12)

HW

8/28/06

CE 461

Floor Diagram (Top view)

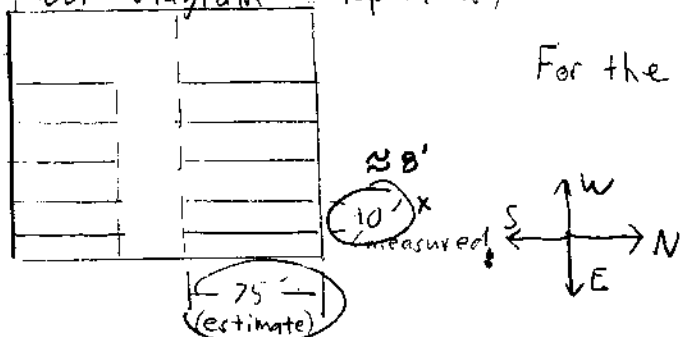
This is not true... The beams support their own floor, their weight, & any live loads on that level. They frame into columns which take the load into the ground. The first level columns support floor loads from above.

I'm impressed w/ the level of thought you've provided - thank you! However, since cars are ABLE to move, they are always considered to be live loads.
